# SERVICE BULLETIN

NO. LFP-001

**Subject:** Cylinder mounting step shifts position

**Models:** DF071554-06  
DF071554-06S  
DF071592-03

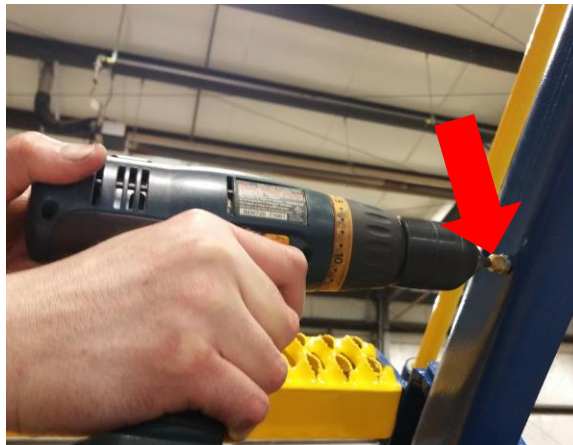
**Problem:** Ladder rung shifts position when ladder cylinder is raised or lowered

**Reason:** Due to elongation of holes during bending process mounting holes cause a misalignment of step when the cylinder is actuated

7. Extend ladder until the cylinder mount steps bolts are accessible Figure 1

**Solution:** The bolts for the mounting step must be removed, then the holes must be aligned. The holes are then to be reamed out to fit bearing in and a new set of bolts are installed. This Removes the problem of extra clearance and stiffens the assembly to stop it from shifting
